**Economic and Social Council**Distr.: General
20 November 2013

World Forum for Harmonization of Vehicle Regulations**Working Party on Passive Safety****Fifty-fourth session**

Global technical regulation No. 7 (Head restraints)**Draft amendment 1 (Phase 2 of the global technical regulation)****Submitted by the informal working group on the Phase 2 of the global technical regulation No. 7***

Figure 1-1 [Goniometry in the test procedure using apparatus that facilitate the measurement of coordinates.]

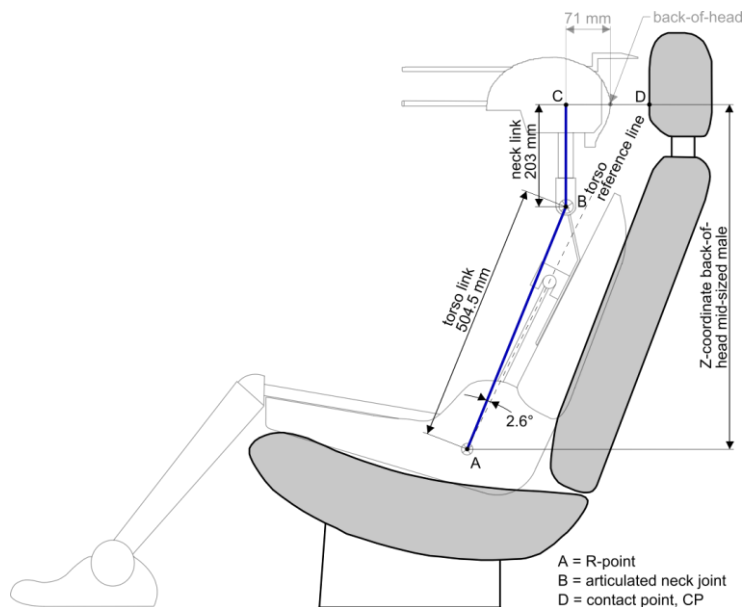
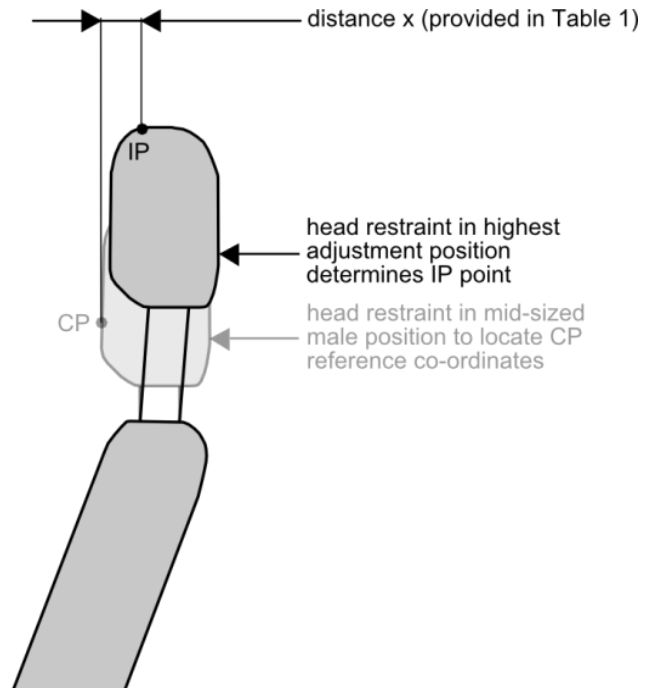
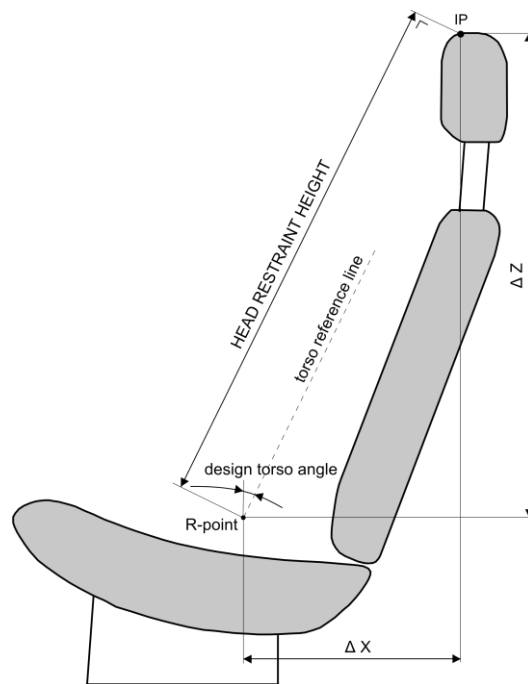
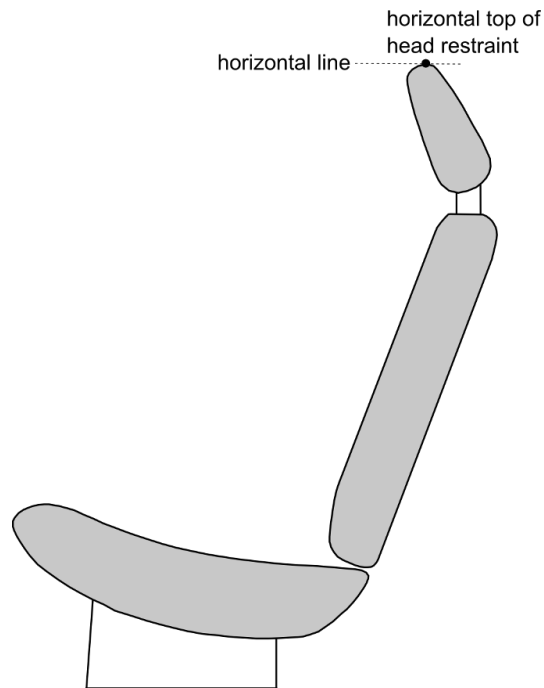
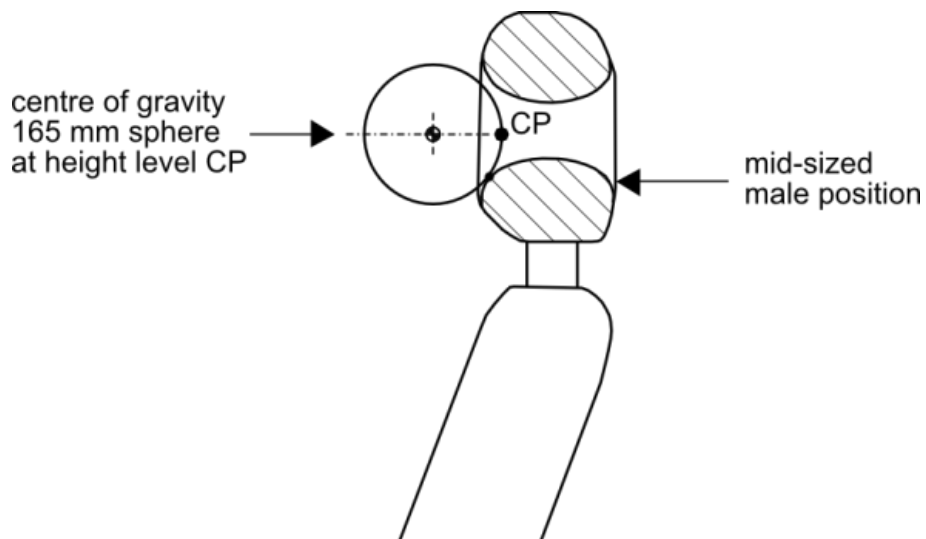
The height measurement apparatus consists of (see Figure 1-1): is based on the usage of apparatus that facilitate the measurement of coordinates.

The CP is defined as the intersection of a horizontal line, on the height of the Z-coordinate of the back-of-head of the mid-sized male (as given in table 1), with the front surface of the head restraint as indicated in Figure 1-1.

The IP is determined on the front surface of the head restraint as the intersection with a vertical line rearwards of CP (see Figure 1-2) at the "distance x" (as given in table 1).

Where IP would be located rearwards of the [horizontal top] of the head restraint, IP will be designated at the horizontal top of the head restraint (see Figure 1-4).

The head restraint height is the distance from the R-point, parallel to the torso reference line and limited by a line perpendicular to the torso reference line intersecting IP (see Figure 1-3).

Figure [X]

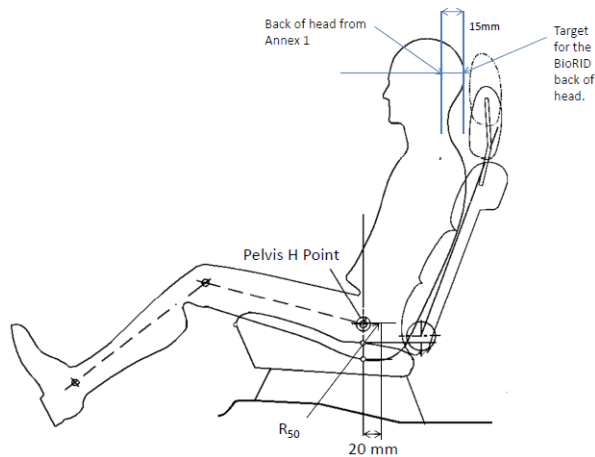
3.2.7.6. The BioRID shall be installed such that its H-point is positioned $20 \text{ mm} \pm 10 \text{ mm}$ forward of the R₅₀-point, as shown in Figure x below, while keeping the pelvis angle within the range specified in paragraph 3.2.6.5. above.

Figure 9-2
Acceleration versus time curve and Permissible Range of curve for the test set-up according to section 3.2. (The target acceleration with time expressed in milliseconds shall meet the value in the table 9-3.)

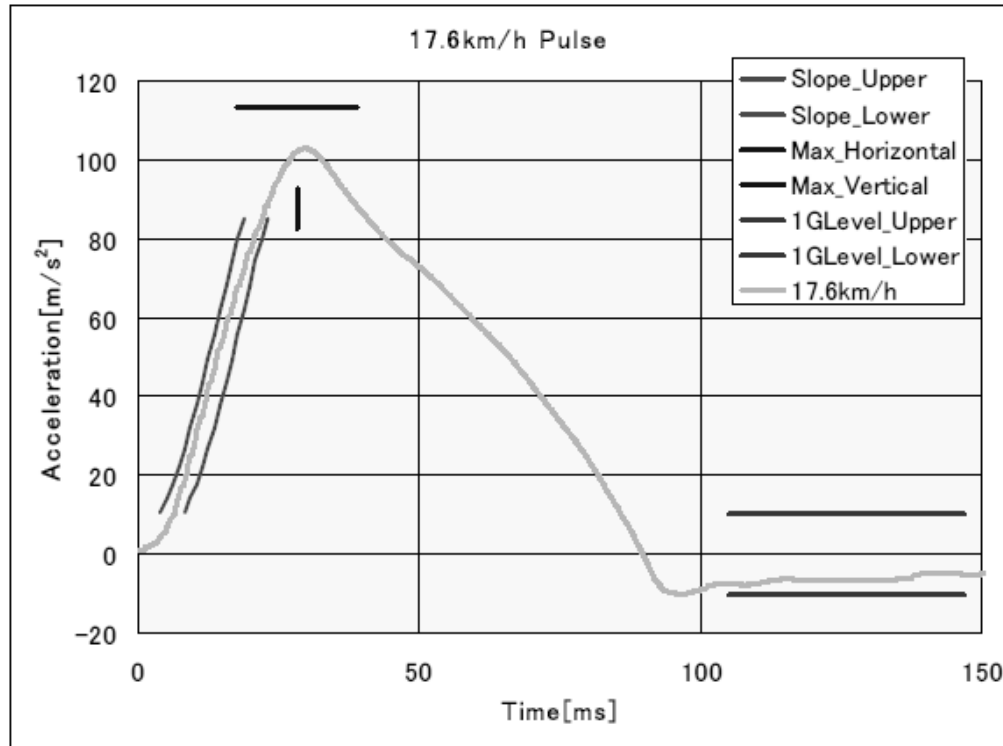
The corridors for the pulse are illustrated in Figure 9-3. [The sled acceleration shall be adjusted within the corridors described in Figure 9-

<i>Definition</i>	<i>Tolerance</i>	<i>Unit</i>
Velocity change	ΔV	17.6	± 0.9	km/h
Duration	ΔT	90.0	± 5.0	ms
Mean acceleration	Mean Acceleration	54.3	± 5.0	m/s ²
T=0 acceleration	AT0	0.0	± 3.0	m/s ²

Figure 11-2
[Dimensions of the 3-D H machine elements and load distribution (Dimensions in millimetres)]

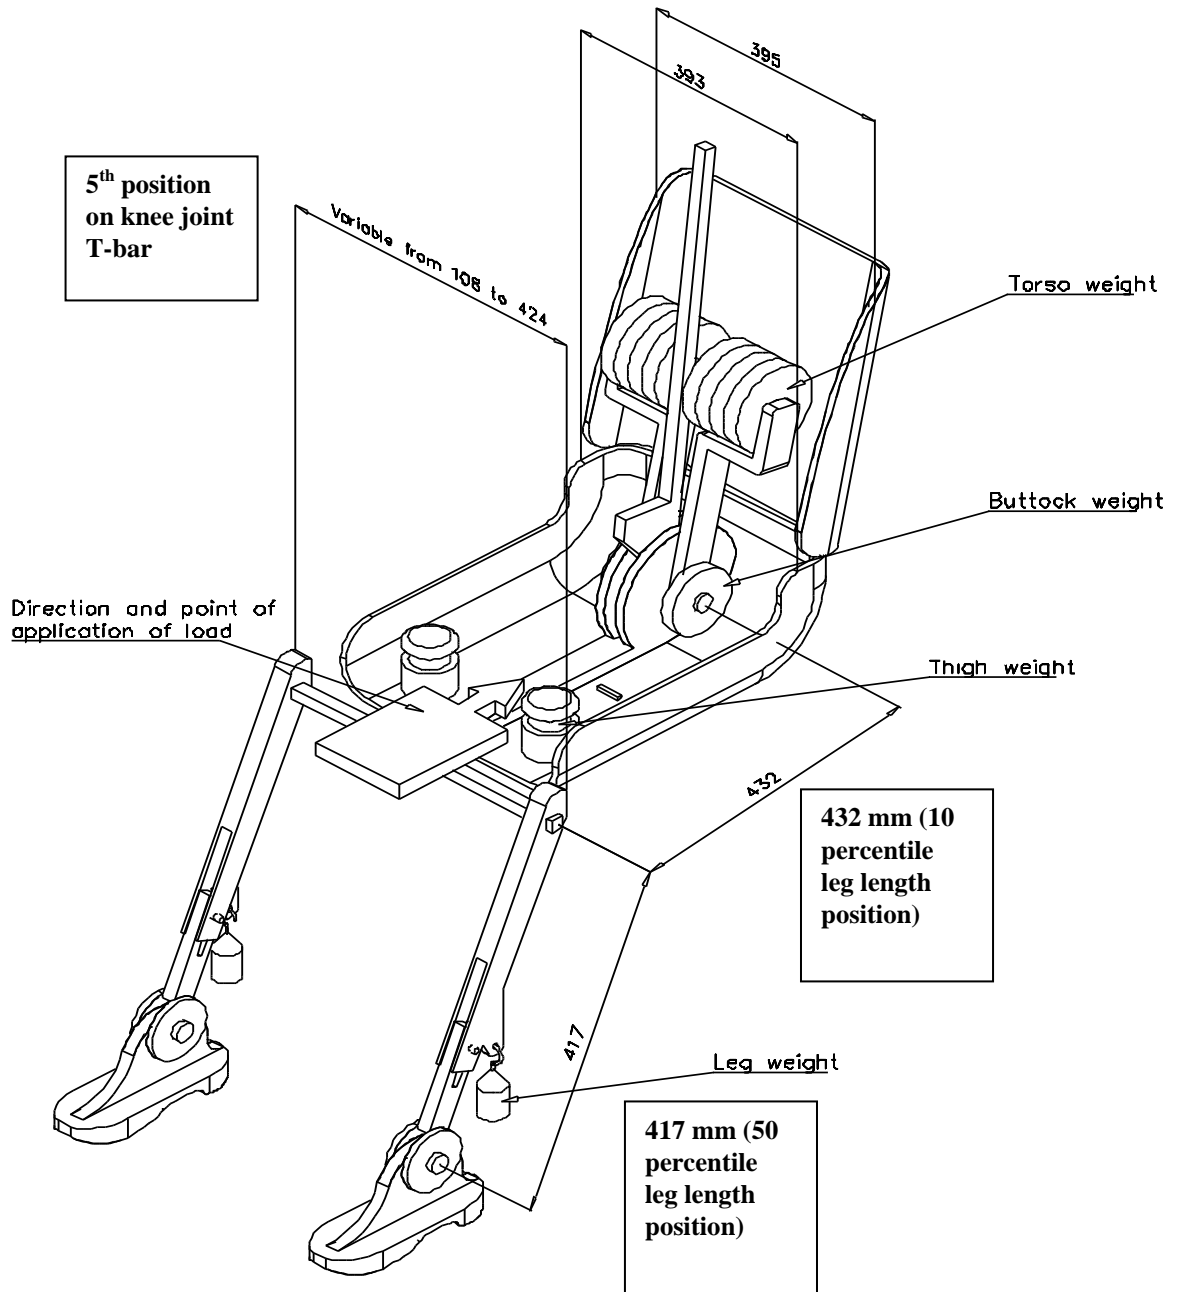
[Latest SAE dimensions for preferred shell width (narrower) favoured: consider implications for other regulations employing 3-DH machine.]
